**Committee of Experts on the Transport of Dangerous Goods  
and on the Globally Harmonized System of Classification  
and Labelling of Chemicals**

**Issues relating to the Globally Harmonized System  
of Classification and Labelling of Chemicals:  
corrosivity criteria**

**Amended proposal for revision of Chapter 2.8 of the Model  
Regulations**

**Transmitted by the expert of the Netherlands and CEFIC**

~~Figure 2.8.2: Flow chart scheme for assignment of packing group for mixtures with hazard classification 8A based on additivity calculations~~

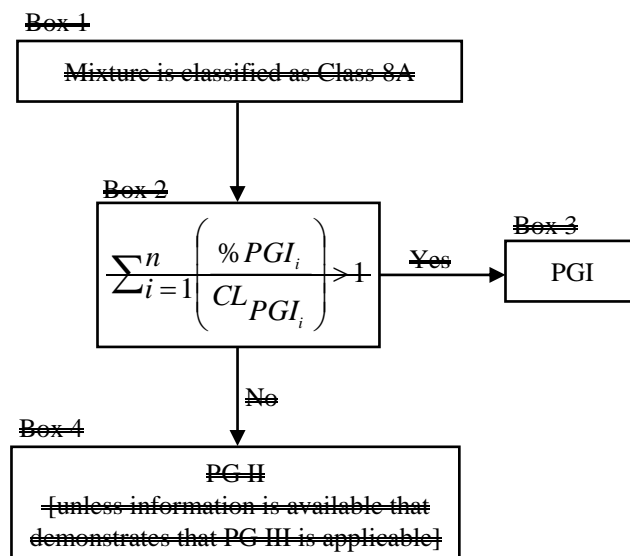
- As a consequence of the simplified additivity approach, Figure 2.8.3 (flow-scheme for assignment of packing group using the additivity approach) and Table 2.8.2 (concentration limits for use by Figure 2.8.3) are no longer needed and have been deleted.

~~2.8.3.4 Notwithstanding 2.8.3.3, the packing group of mixtures classified as Class 8A based on additivity calculations (see 2.8.2.3.3.2 and 2.8.2.3.3.3) may be assigned using the following method:~~

**Figure 2.8.3.2: Flow chart scheme for assignment of packing group for mixtures classified as Class 8 without sub-classification based on non-additivity**

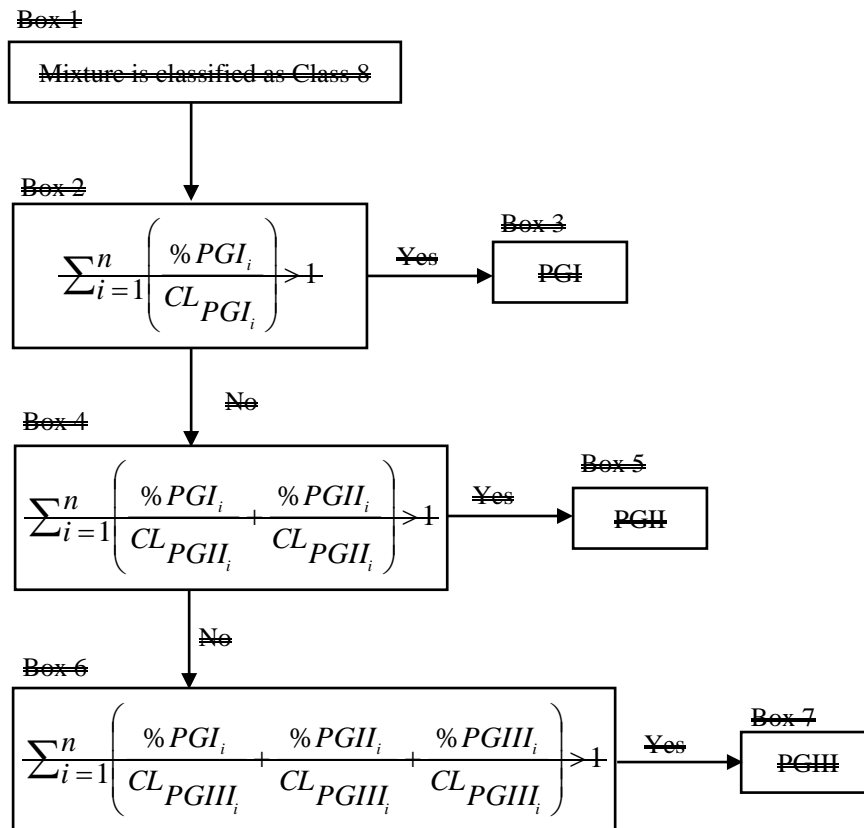
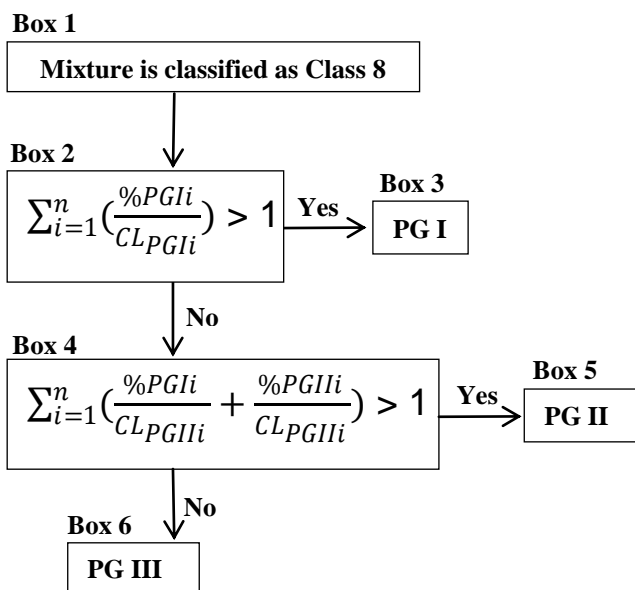
- Figure 2.8.4 (flow-scheme for mixtures in Class 8 without sub-classification) has been simplified. Box 6 for calculations of PG III was superfluous and has been deleted. Mixtures classified as Class 8 and which are not assigned to packing group I or II will per definition be in packing group III.

- As a consequence of a simplified flow-scheme for mixtures classified as Class 8 without sub-classification, generic concentration limits for PG III are no longer needed.

~~*% PG III<sub>i</sub> is the concentration of ingredient i assigned to packing group III.*~~

~~*CL<sub>PG III<sub>i</sub></sub> is the concentration limit for ingredient i in PG III. This concentration limit can be either a specific concentration limit taken from the Dangerous Goods List or the generic concentration limit from Table 2.8.4.*~~

2.8.3.5.4 Notwithstanding 2.8.3.3 (d), the packing group of mixtures classified as Class 8 without sub-classification may be assigned using the following method:

- (b) Identify the specific or generic concentration threshold for each individual ingredient. For some substances listed by name on the Dangerous Goods List, the concentration threshold can be taken directly from the list. If no specific concentration threshold is available, generic concentration threshold listed in Table 2.8.4 shall be used;
- (c) Assign the packing group for the mixture in accordance with Figure 2.8.3.2.

Generic Concentration Limit	Concentration
CL PG I	[5% ] <del>[50%]</del>
CL PG II	[3% ] <del>[5%]</del>
<del>CL PG III</del>	<del>[1%]</del>
